# Technical Bulletin

Bulletin Number: 510 Revision Number: R-01

**SUBJECT:** VENDER DEFENDER POSITIONING BRACKET

**MODELS AFFECTED:** All VRV Non-Coke Venders Serialized 1970-6462AW to 0001-6492CW.

Figure 1

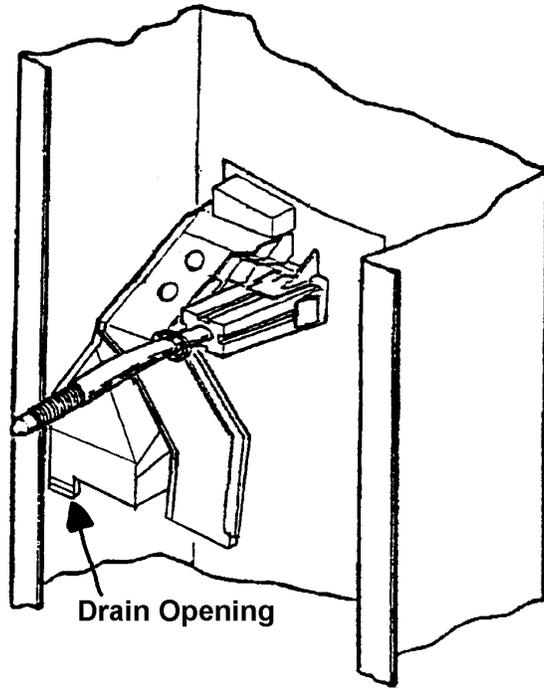
**REASON:** To provide a field kit to improve the vender defender / changer hopper alignment.

**ORDER:** 1 - 592,010,05x.x3 Vender Defender Positioning Bracket

1. Locate the two (2) keps nuts on the vandal panel behind the drain opening of the vender defender.
2. Remove the vandal panel keps nut closest to the front of the main door.
3. Place the vender defender positioning bracket in position so the bracket sets behind the drain opening of the vender defender.
4. Install the keps nut removed in step 2.
5. Tighten the keps nut to secure bracket in place.
